Bid Addendum

Addendum No. 1 for the City of Staunton Cole Avenue Sanitary Sewer and Stream Restoration project.

Addendum Date: May 15, 2022

Sheet #
14 of 27

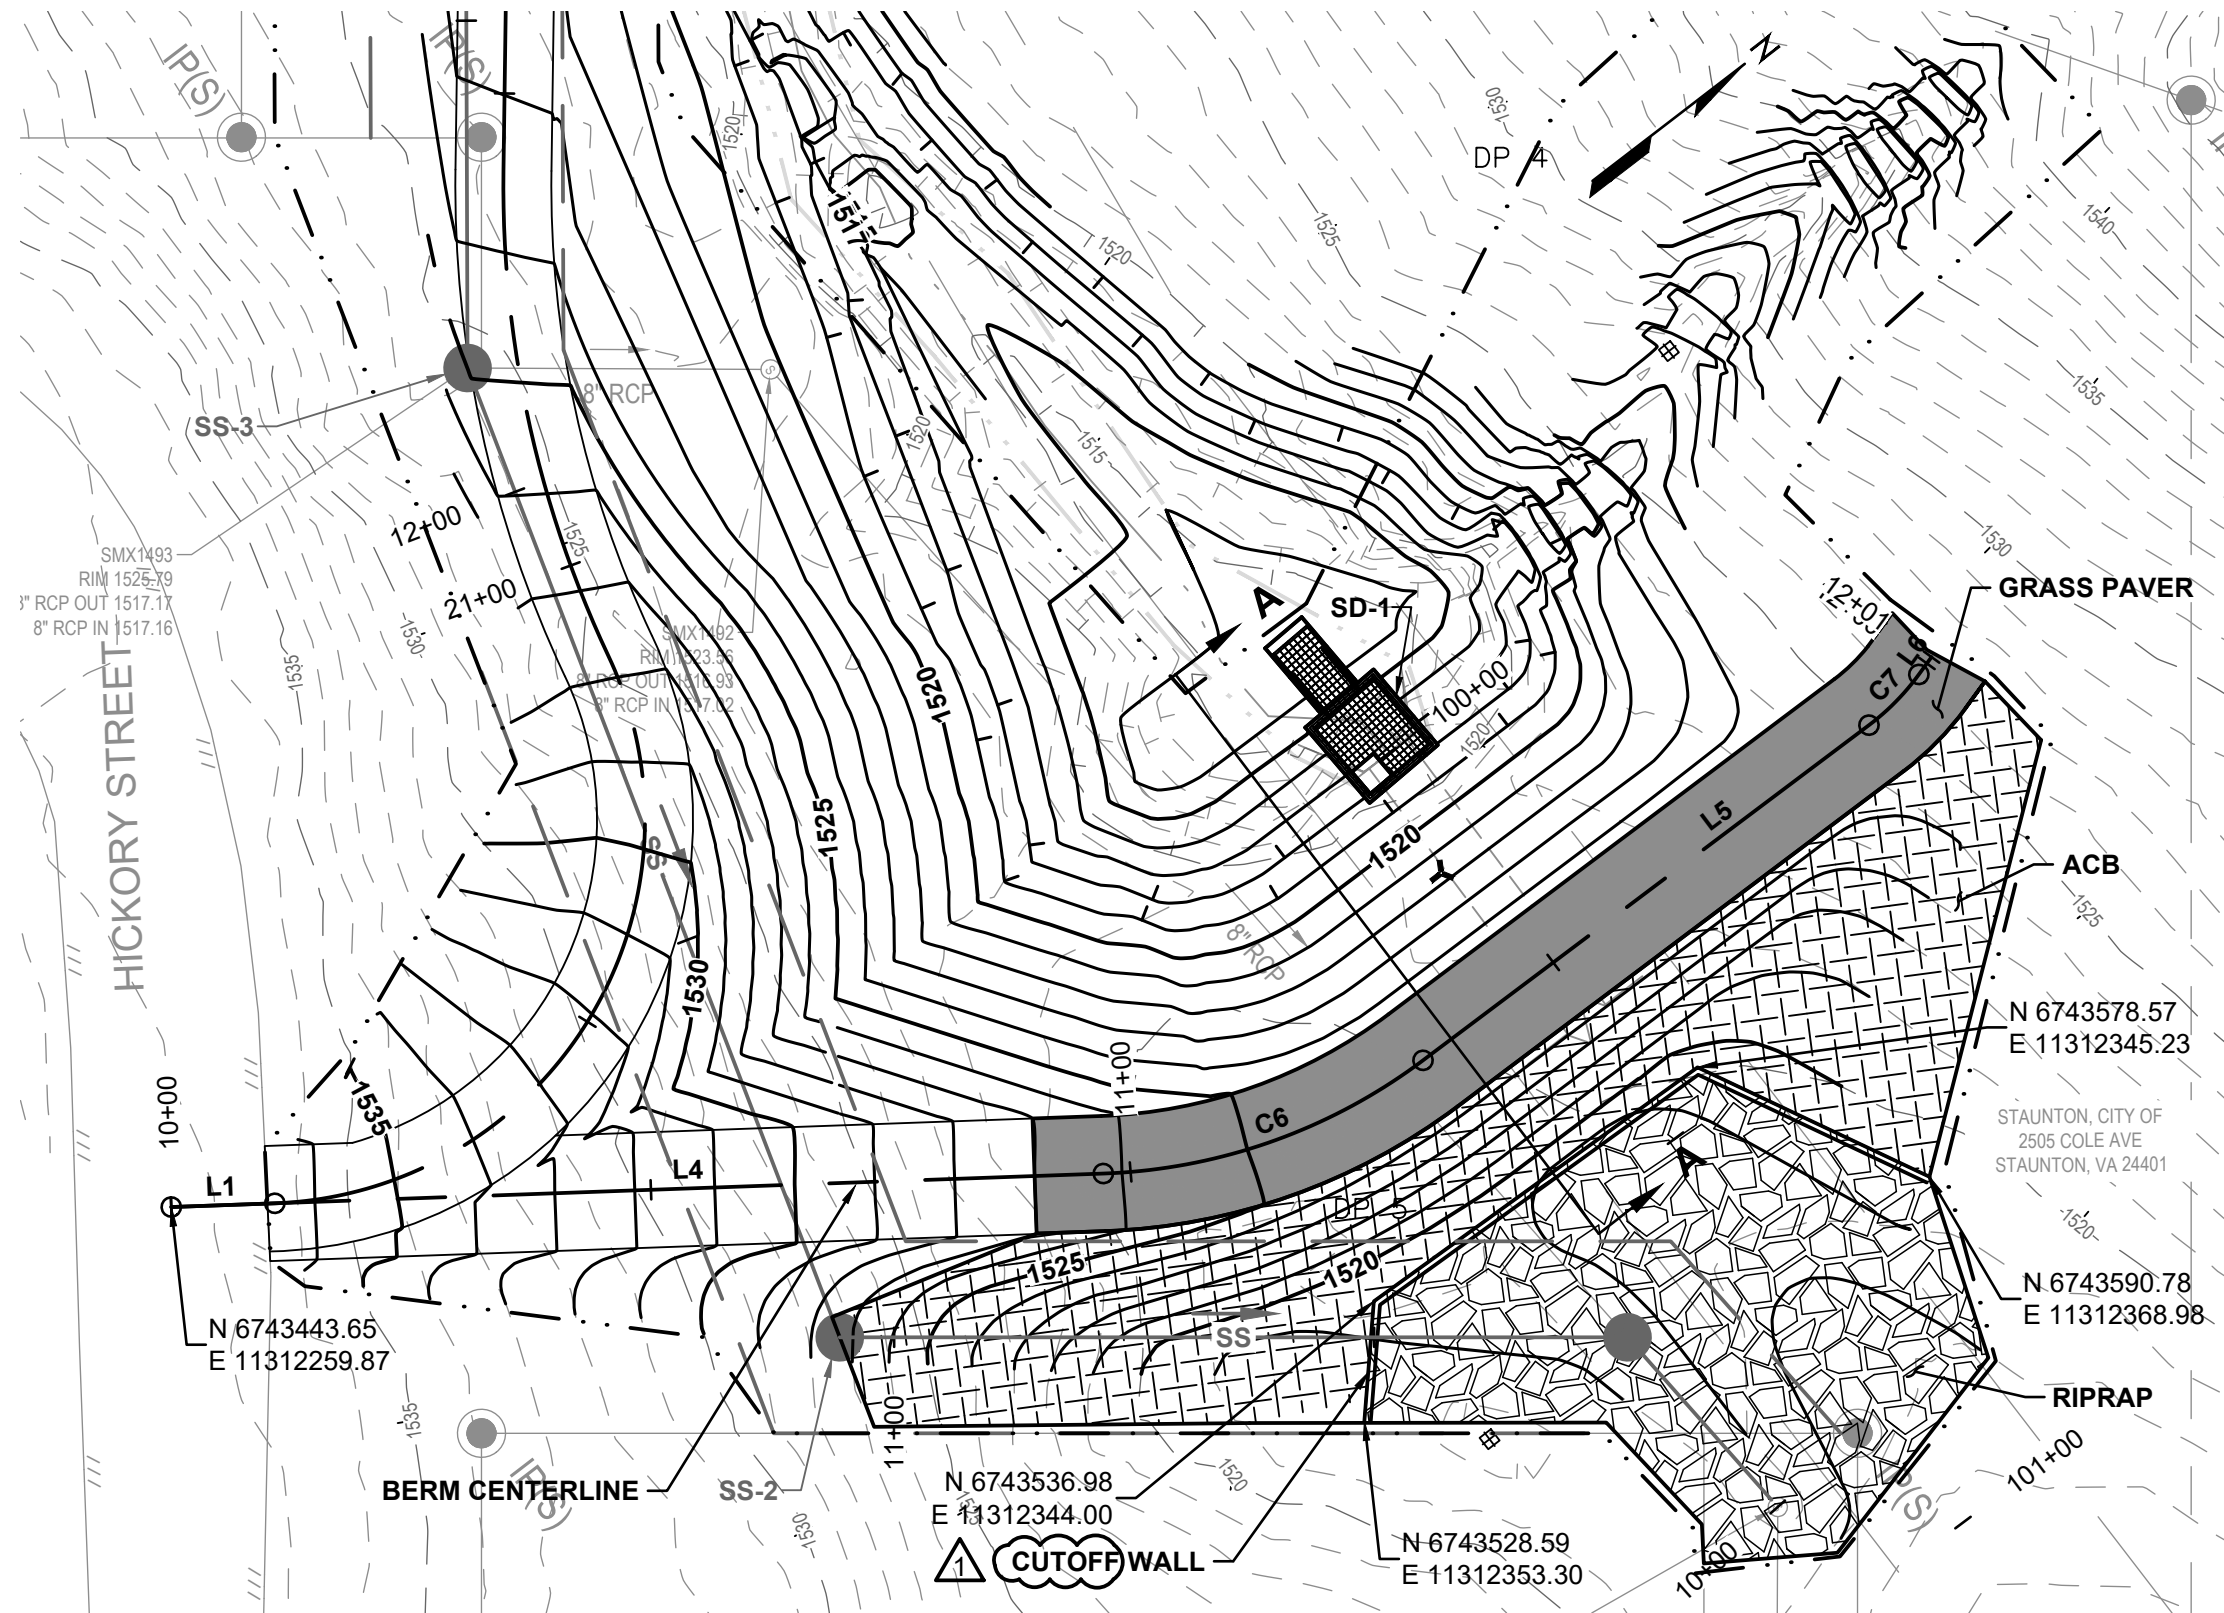
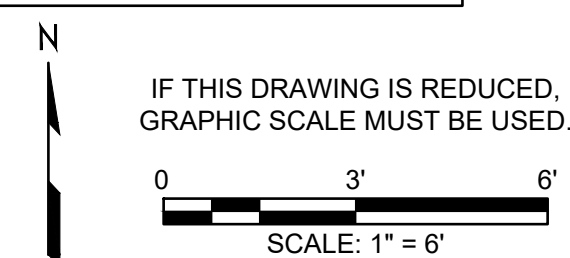
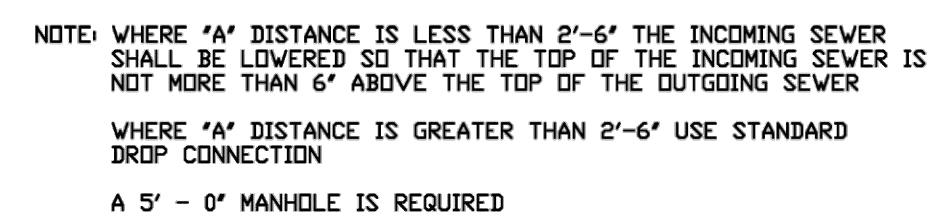
Question 11: Can the outlet structure (detail on sheet 14 of the plans) be precast, or will this have to be cast in place?

1. Drawing Sheet 13 of 27: Drawing Sheet 13 of 27 has been re-issued to replace “A-JACK” with “CUTOFF” in reference to the concrete that is being placed between the ACBs and the Riprap, and inclusion of a note for embankment fill material compaction.
2. Drawing 14 of 27: Drawing 14 of 27 has been re-issued to replace “A-JACK” with “CUTOFF” in reference to the concrete that is being placed between the ACBs and the Riprap, inclusion of a note for embankment fill material compaction, and adding a section view of the concrete cutoff wall at the existing 60-inch pipe.

Response: Precast structure meeting the requirements is acceptable.
